Administrative Approval Action

Case File / Name: SUB-0019-2022
DSLCL - Elm Park (SUB)

REQUEST: Development of a vacant 7.12 acre/313,419 sf tract zone RX-5-CU. Proposed 63 3-bedroom townhomes and two HOA common lots development on existing Lots 2 & 3 (per subdivision SUB-75-2020). A total of 65 lots will be created.

FINDINGS: City Administration finds that this request, with the below conditions of approval being met, conforms to the Unified Development Ordinance. This approval is based on a preliminary plan dated May 6, 2022 by JOHN A. EDWARDS & COMPANY.

**LANDSCAPE
PLAN**

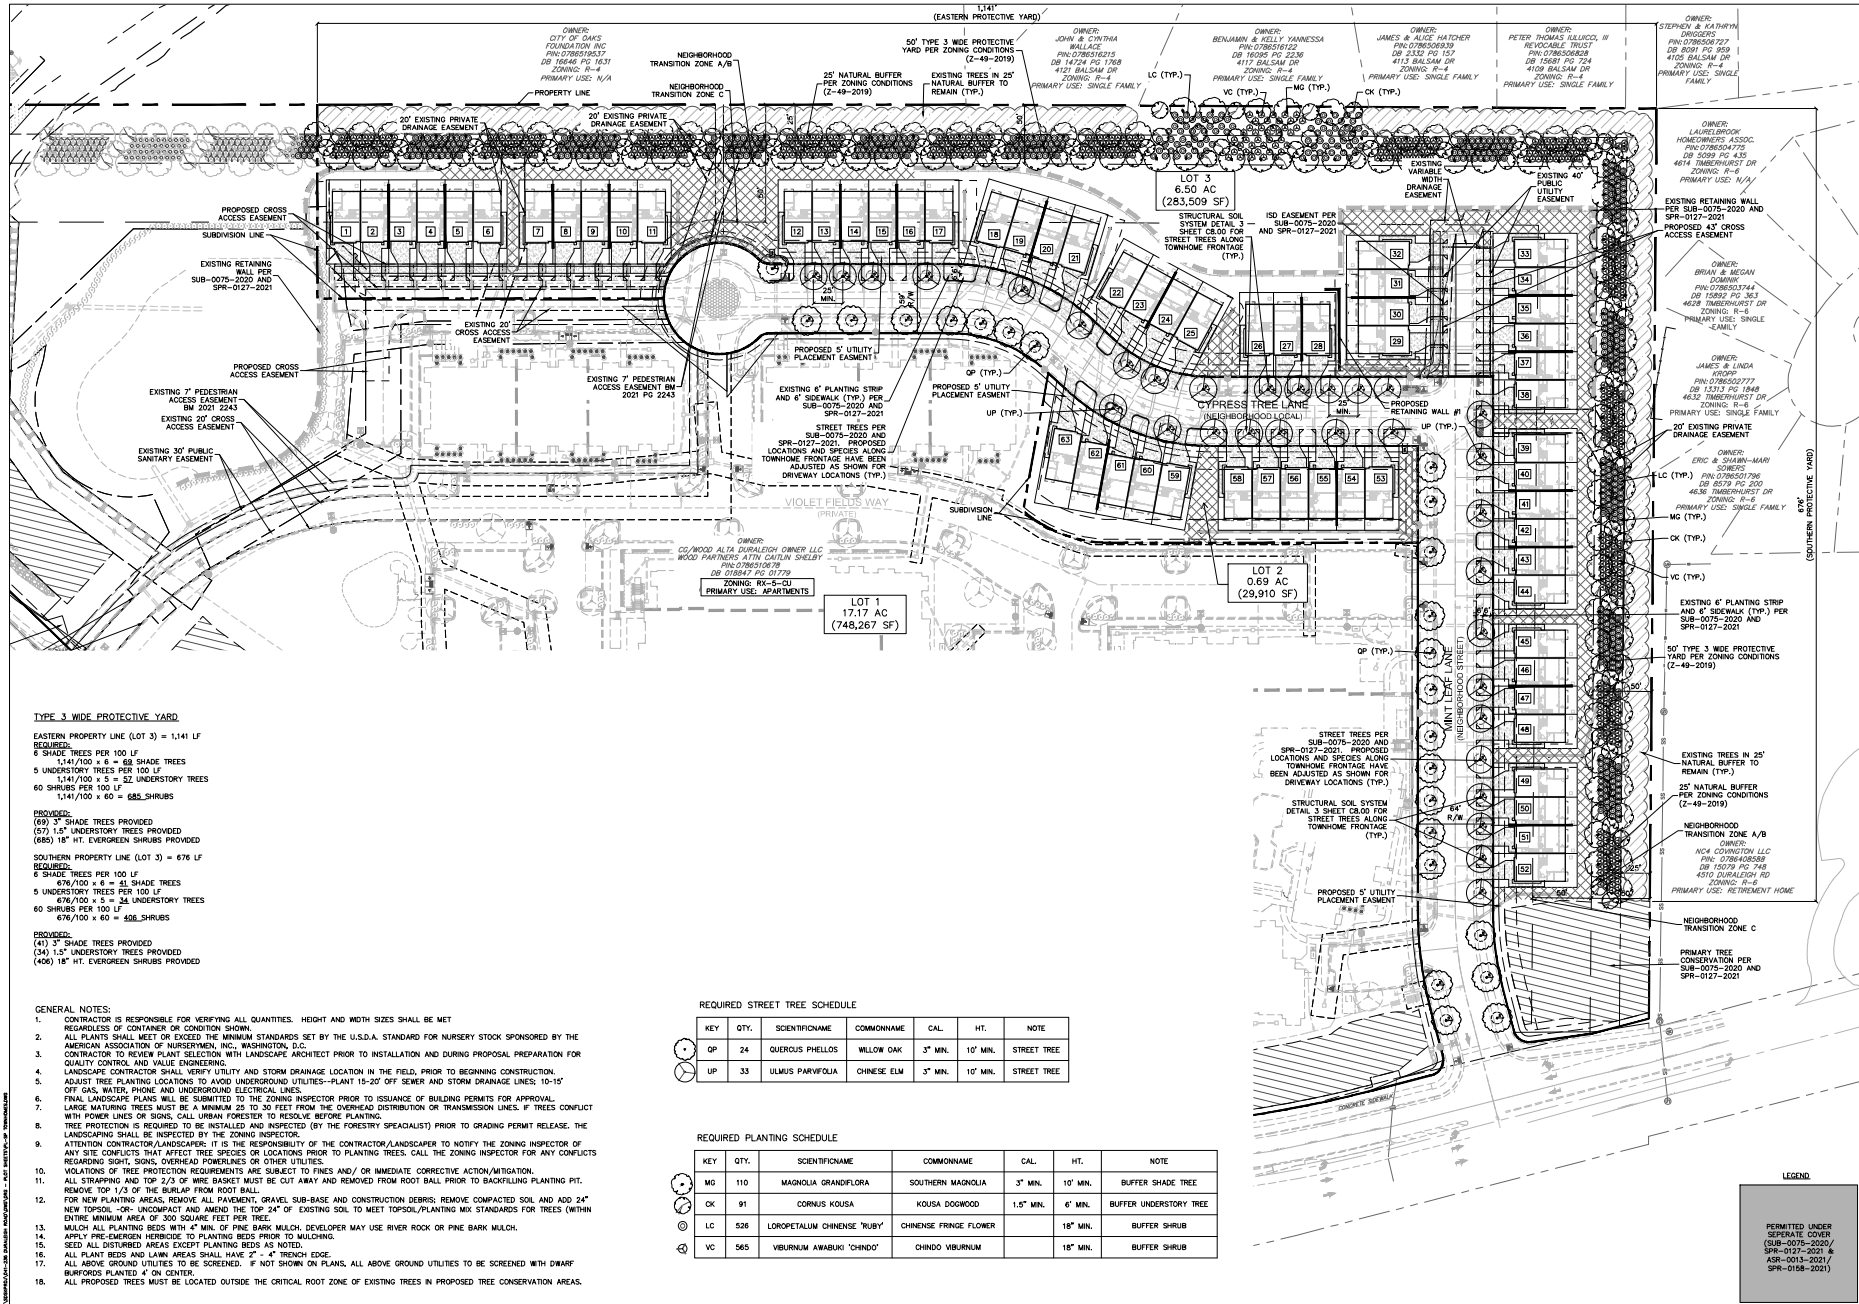
4. Grading sheet C4 notes the TW/BW grade levels for new proposed retaining walls and demonstrate compliance with UDO Sec.7.2.8.D.
5. The proposed landscaping plantings comply with easement designs for the Private Drainage Easement (PDE) location and plantings, including any redesigns or layouts, are confirmed with the Stormwater division prior to civil plan approval.
